DUKE POWER COMPANY

Re: Catawba Nuclear Station
Docket Nos. 50-413 and 50-414

ENCLOSURE B
ADDITIONAL INFORMATION

CATAWBA SURGE LINE

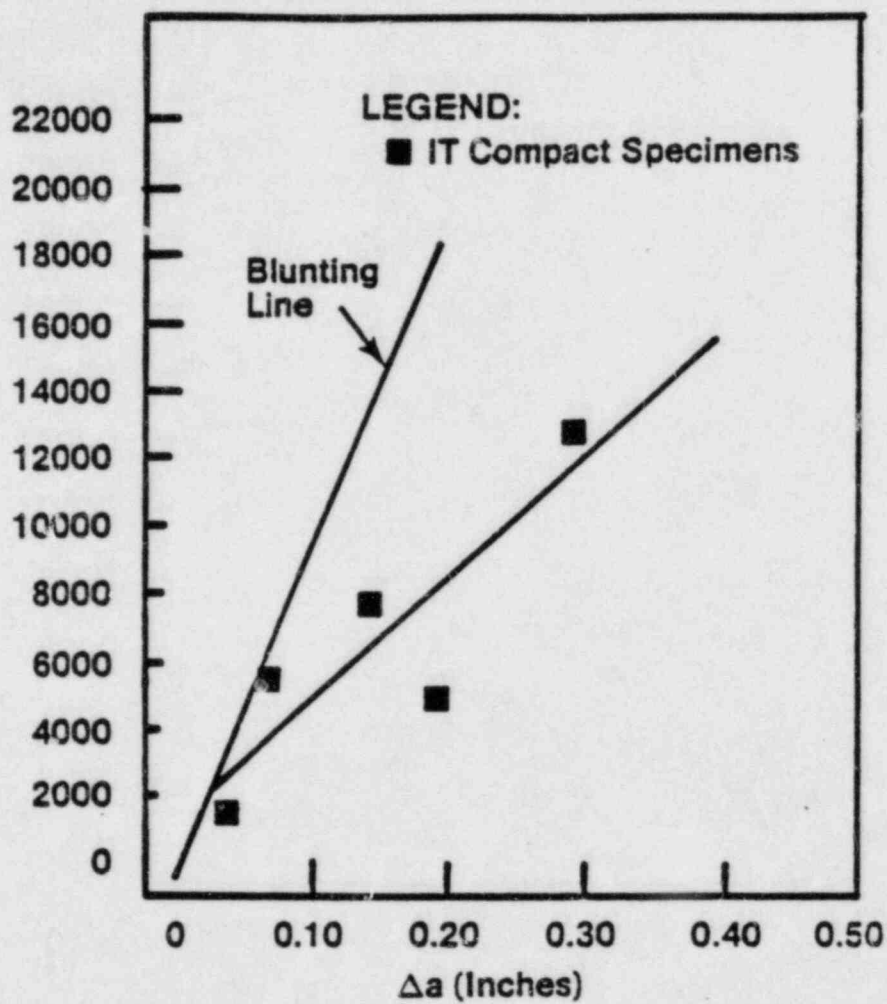
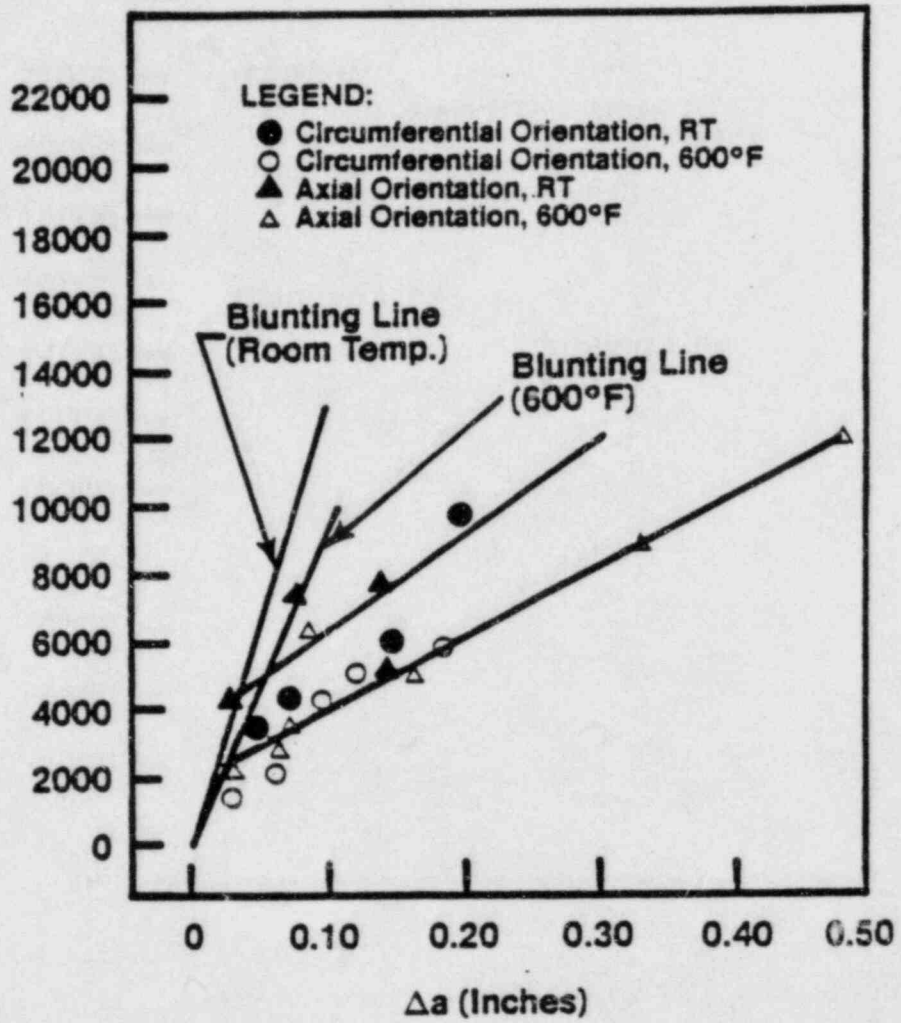
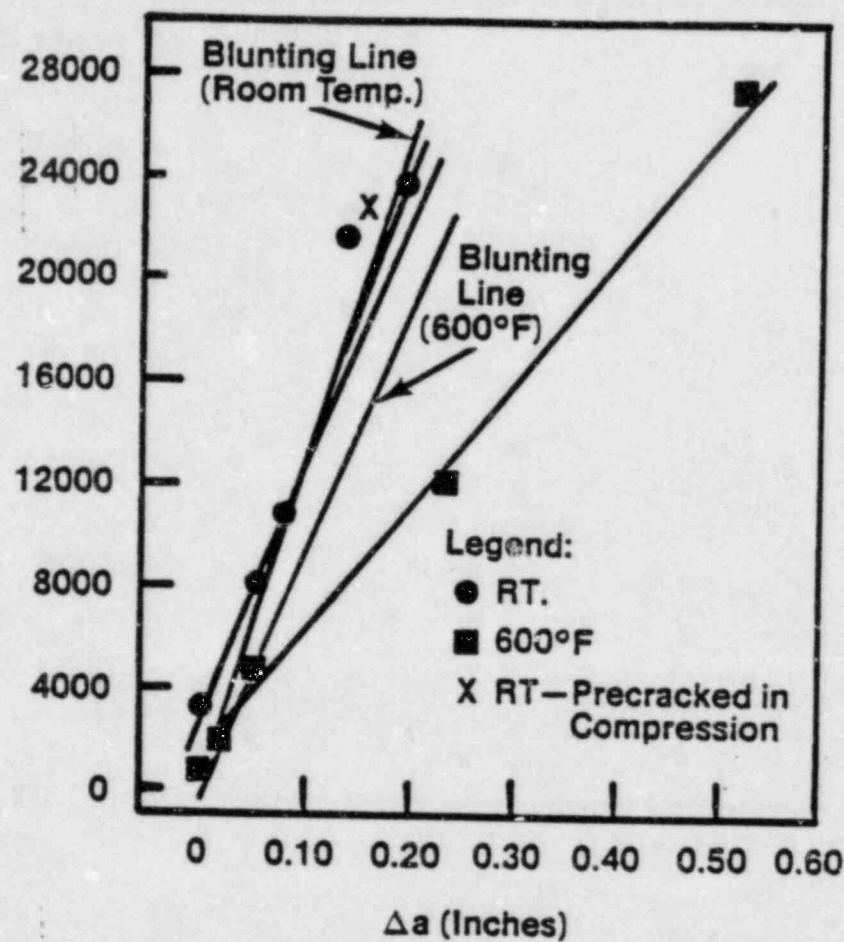
The Paragraph at the top of page 3-2 of Reference (a)*below identifies the weld connection between the [] as being a,c,e
the limiting location to be analyzed. Figure 7-2, page 7-12, is a schematic drawing of this location. Provide the materials properties for the weldment as well as for the base metal, preferably in the form of a J-resistance plot. State the maximum value of J-material to be considered in your analyses and your basis for it.

The fracture toughness J_{IC} used for the 304 forged pipe was obtained from the compilation of test results for this material reported in Reference 1. The table of toughness results presented in this reference is reproduced in the attachment. It is easily seen that the value of [] used in a,c,e
the report is the minimum of the three sets of test results reported. The J integral R curves for each of the three sets of tests at 600F are also provided in the attachment, and are the original figures from Reference 1.

The maximum value of J obtained in the fracture tests is in excess of 25000 as may be seen from examining the plots attached for base metal tests. The maximum value of J obtained in the weld metal tests was in excess of [] in-lb/in². a,c,e
